## **JUNCTION CITY LAND USE FINDINGS FOR A TYPE-I DEVELOPMENT REVIEW**

**File Number:** DEV-22-26, 135 E 1<sup>st</sup>

**Summary of Findings:** Development Review conditional approval is granted to allow construction of a 37,800 square foot industrial building located to the west of an existing building #5 on property zoned Light Industrial (M1).

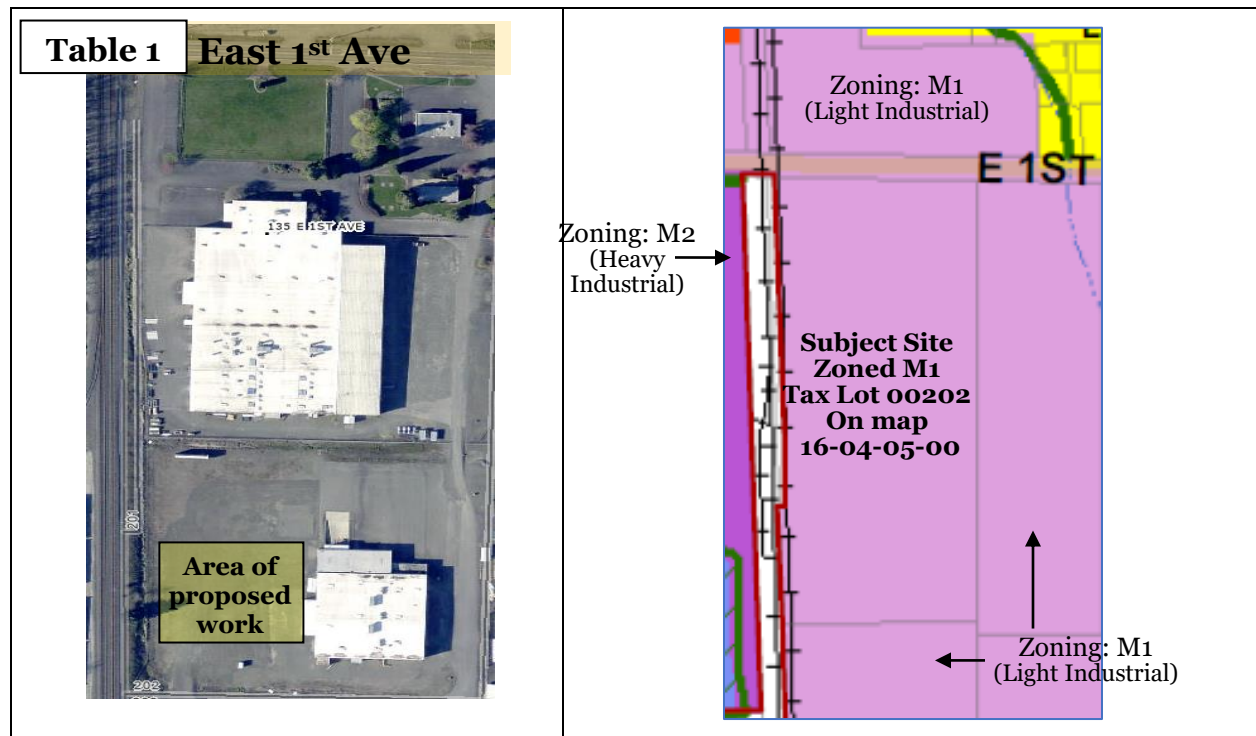
3. Per JC PWDS section 3.10.d.1, “Pre-development shall be defined as a site with natural vegetation on native soil.” Therefore, when comparing peak runoff rates for pre- and post-development where development is proposed, the pre-developed condition shall be natural vegetation on native soil (regardless of the current condition) and the post developed condition is based on the proposed surface.
